Record Summary for Board of Adjustments

Record #	Status	Opened Date
BOA-26-000013	In Review	02/25/2026

RES-POOL-25-000384 (9612 ROCKBROOK DR)

THE WITTER RESIDENCE
 9612 ROCKBROOK DR
 DALLAS, TEXAS 75220

SITE PLAN
 PLAN DATE: 21NOV25

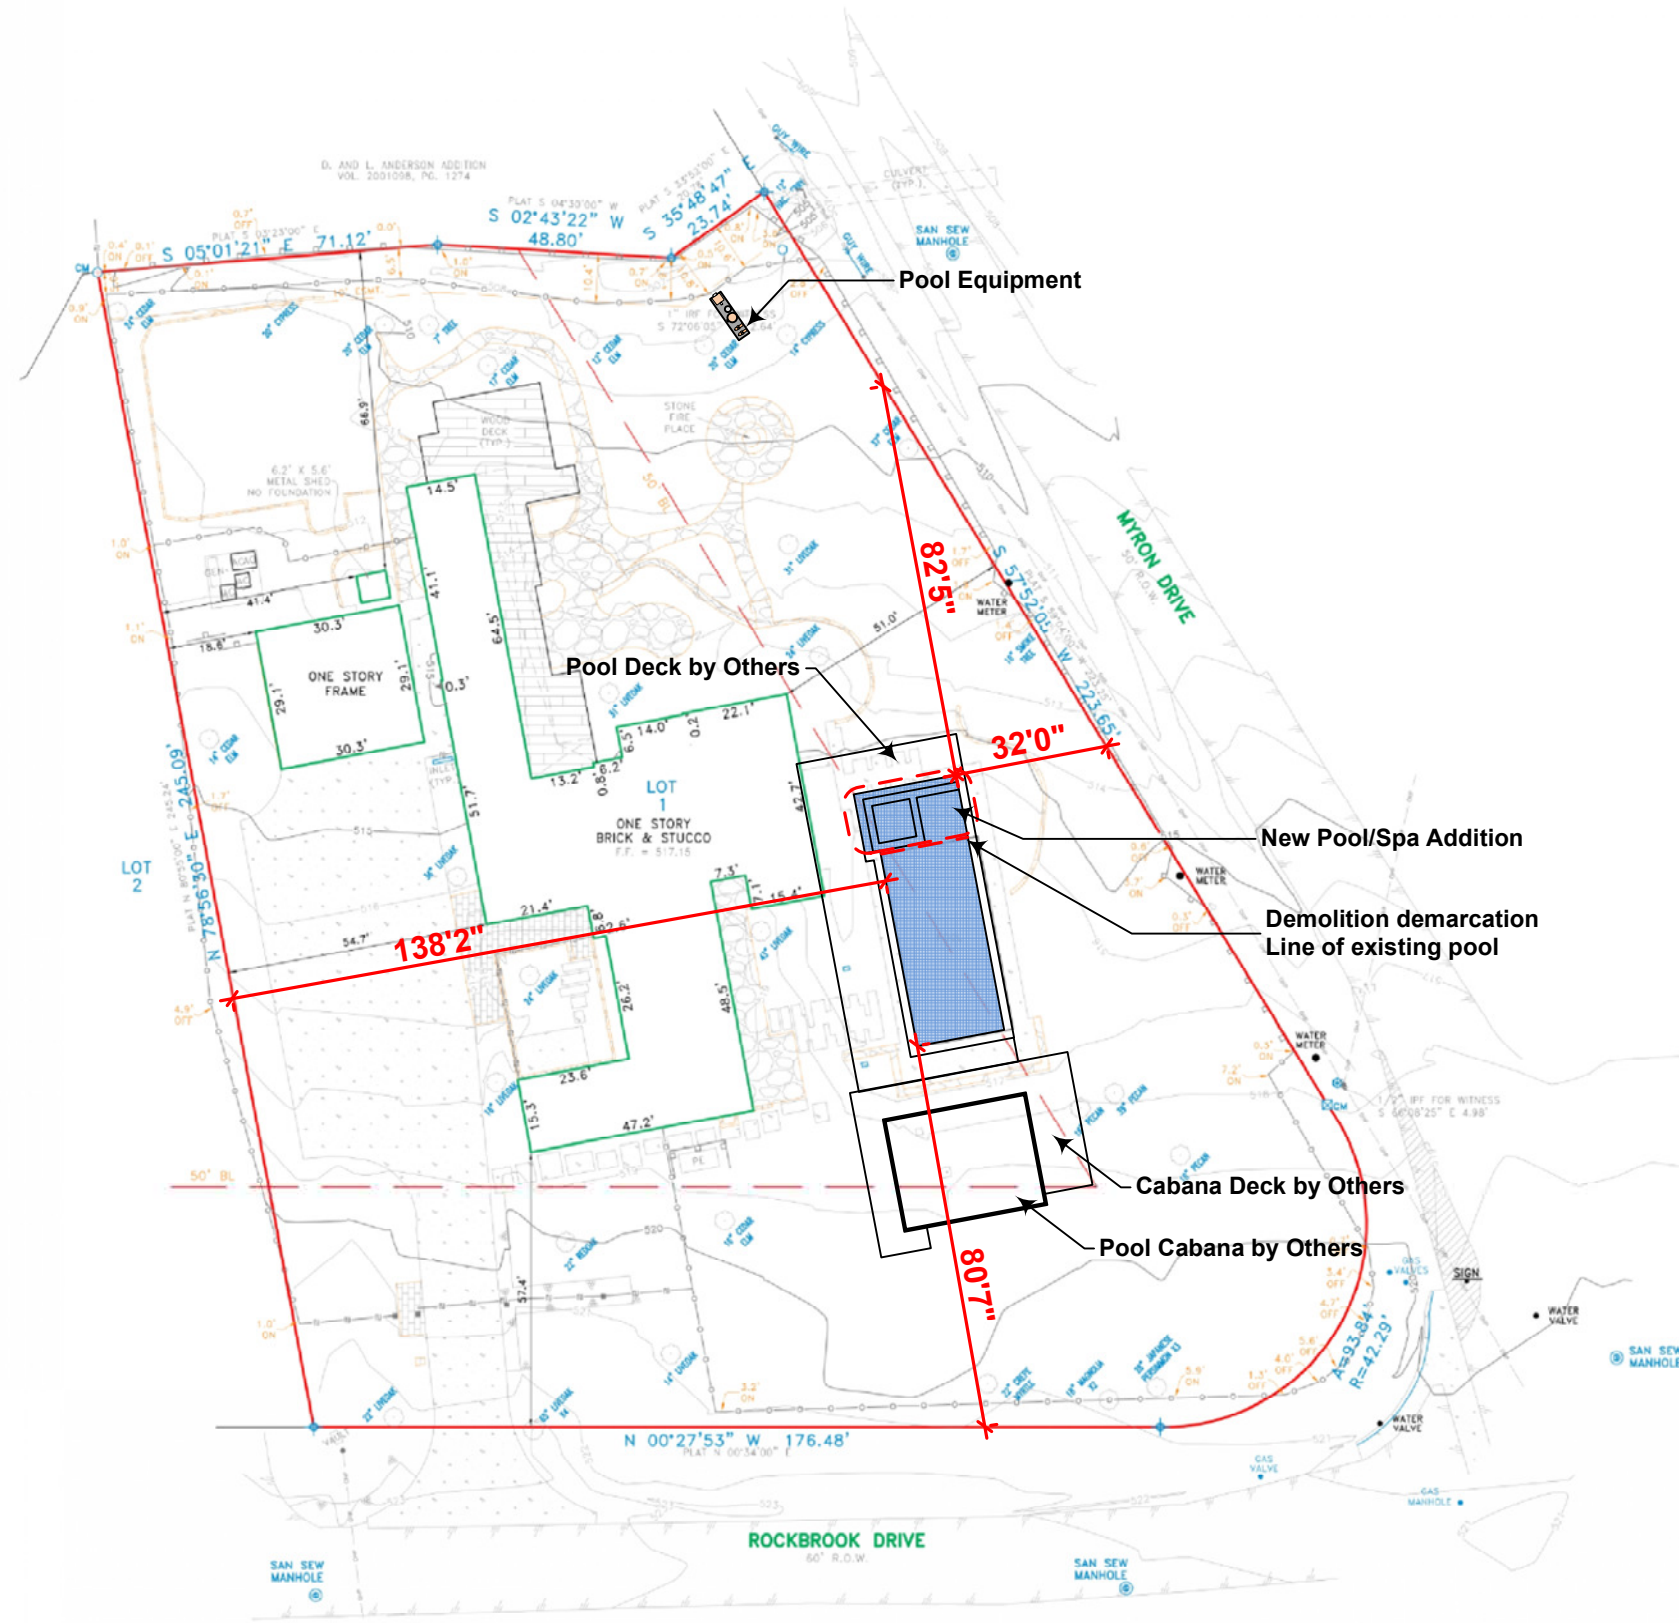
1- Please provide previous pool plans with dimensions because of the addition on of the pool. New Pool/spa addition. Will need to go to the Board of Adjustment for the new addition of the pool.
